**Proposal #20: 1185-03-71, WISC 2021 177
Saxon – Hurley
CTH B to Michigan State Line
USH 2
Iron County**

This is Addendum No. 01, which provides for the following:

ADDENDUM NO. 01

1185-03-71

Figure 1: Nuclear/Core Correlation Location Layout

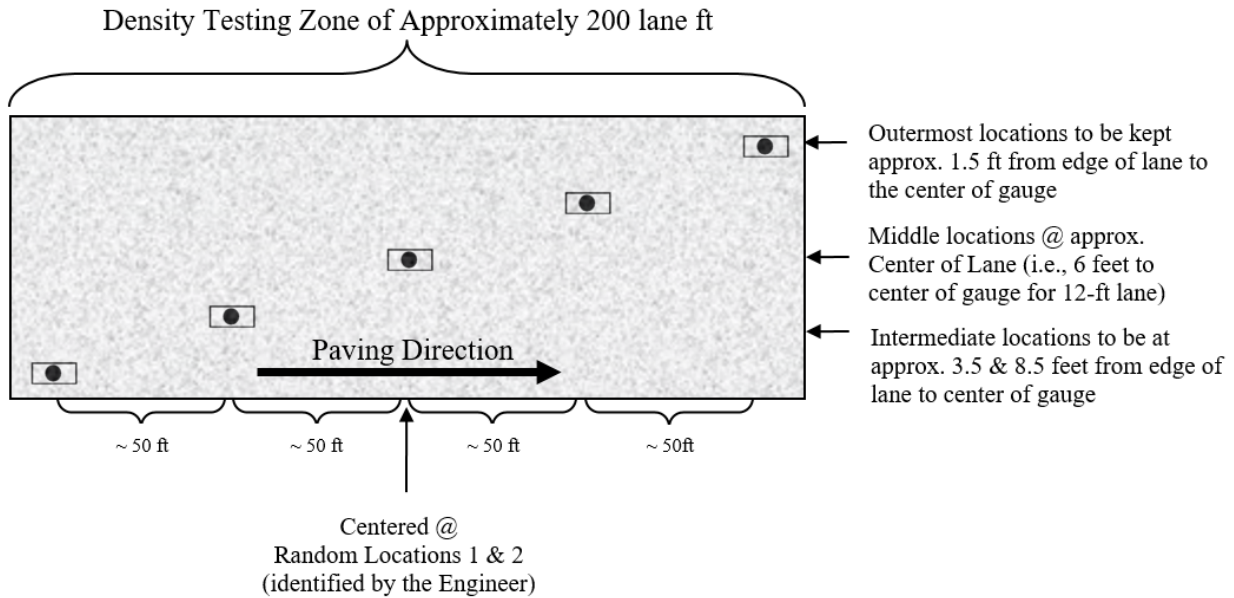
The engineer will identify two zones in which gauge/core correlation is to be performed. These two zones will be randomly selected within each *half* of the test strip length. (Note: Density zones shall not overlap and must have a minimum of 100 feet between the two zones; therefore, random numbers may be shifted (evenly) in order to meet these criteria.) Each zone shall consist of five locations across the mat as identified in Figure 1. The following shall be determined at each of the five locations within both zones:

Individual locations are represented by the  symbol as seen in Figure 1 above. The symbol is two-part, comprised of the nuclear test locations and the location for coring the pavement, as distinguished here:

Figure 4: Locations of main lane HMA density testing (QC=solid lines, QV=dashed)

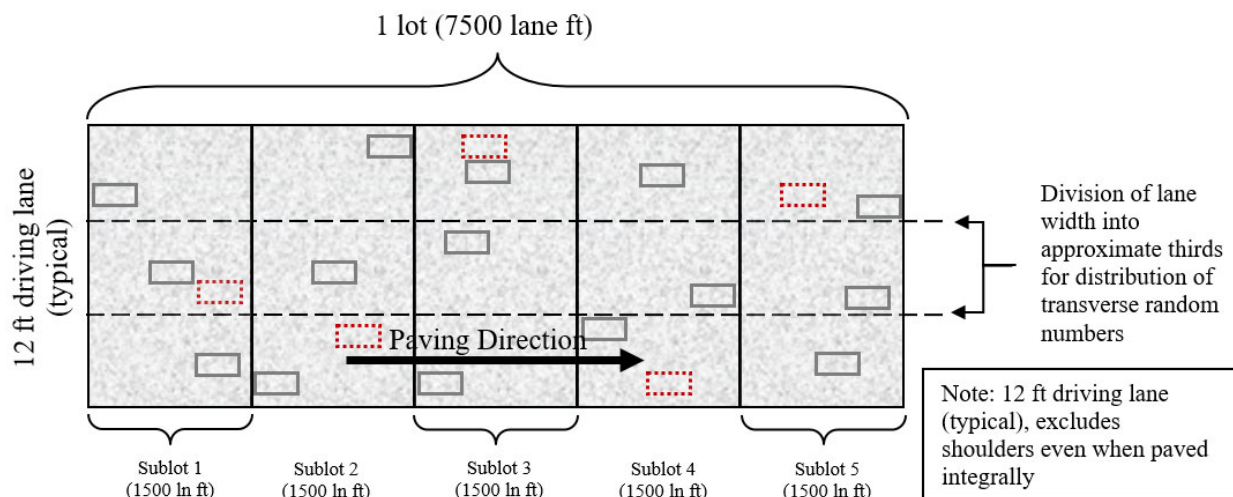
For nuclear density testing of the pavement beyond the test strip, QC tests will be completed at three locations per subplot, with a subplot defined as 1500 lane feet. The three locations will represent the outside, middle, and inside of the paving lane (i.e., the lane width will be divided into thirds as shown by the dashed longitudinal lines in Figure 3 and random numbers will be used to identify the specific transverse location within each third in accordance with CMM 8-15). Longitudinal locations within each subplot shall be determined with 3 independent random numbers. The PWL Density measurements do not include the shoulder and other appurtenances. Such areas are tested by the department and are not eligible for density incentive or disincentive. Each location will be measured with two one-minute gauge readings oriented 180 degrees from one another, in the same footprint as detailed in Figure 2 above. Each location requires a minimum of two readings per gauge. The density gauge orientation for the first test will be with the source rod towards the direction of paving. QV nuclear testing will consist of one randomly selected location per subplot. The QV is also comprised of two one-minute readings oriented 180 degrees from one another. For both QC and QV test locations, if the two readings exceed 1.0 pcf of one another, a third reading is conducted in the same orientation as the first reading. In this event, all three readings are averaged, the individual test reading of the three which falls farthest from the average value is discarded, and the average of the remaining two values is used to represent the location for the gauge. The subplot density testing layout is depicted in Figure 4, with QC test locations shown as solid lines and QV as dashed.

WisDOT Longitudinal Joint – Nuclear Gauge Density Layout

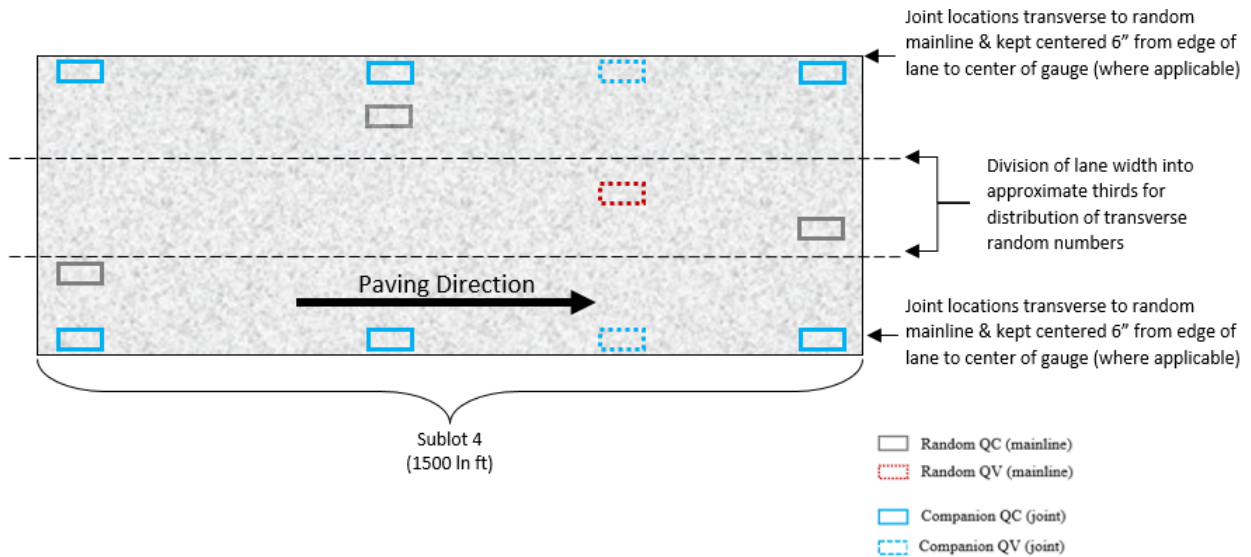
Each QC and QV density location must have a companion density location at any applicable joint. This companion location must share longitudinal stationing with each QC or QV density location and be located transversely with the center of the gauge 6-inches from the edge of the paving area.

For HMA Pavement Percent Within Limits QMP projects, this appears as follows:
